Access Compliance Report

Public Rights-of-Way

Intersection ID: 14431	Main Street: N_COLONIAL_AV	Cross Street: RANDOLPH_RD	Location: SW
ADA ID: 7B423ADAF421	Ramp Type: PerpDiag	Initial Pass/Fail: Pass	Overall Compliance: No
		Severity Score: 12.5

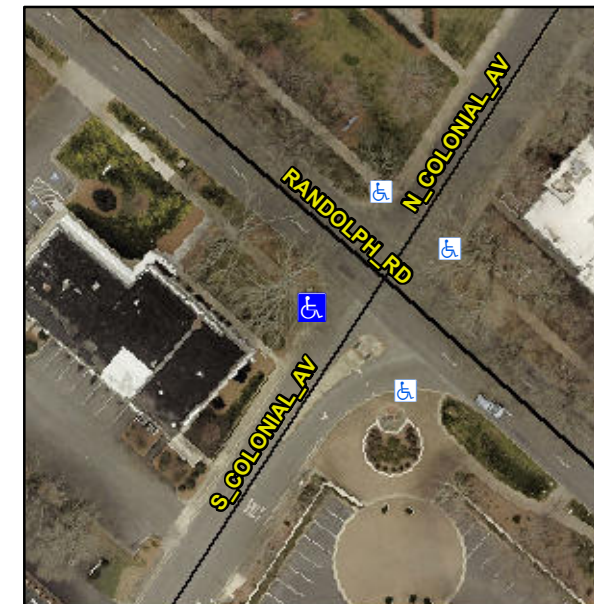
Not Found, R304.2.1, R304.2.2-Perp, R304.3.2-Para, R304.5.3, R305.1.4, R305.2

Remove & Replace Curb Ramp With Two New Directional Ramps or Equivalent. Remove & Replace Gutter.
